Technical Service Bulletin: tsb100311

Released Date: 06-Oct-2004

New Front and Rear Crankshaft Oil Seals

Figure 1 Front Crankshaft Oil Seal

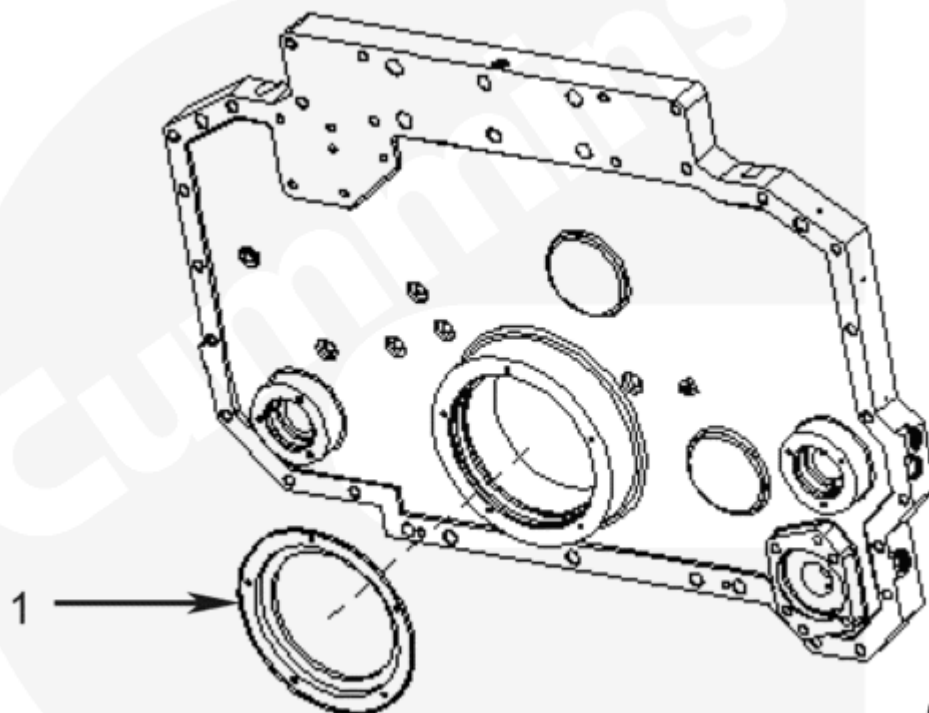
This Technical Service Bulletin details the introduction of new front and rear crankshaft oil seals on the QSK45, QSK60, and QSK78 series engines. The new seals have been released to improve durability of system components.

The introduced oil seals are backward compatible and can be fitted as direct replacements. Mounting hardware remains unchanged for both front and rear seals.

Ref	New Seal	Old Seal	Seal Position
1	4100624	4066222	Front Seal
2	4100625	4066223	Rear Seal
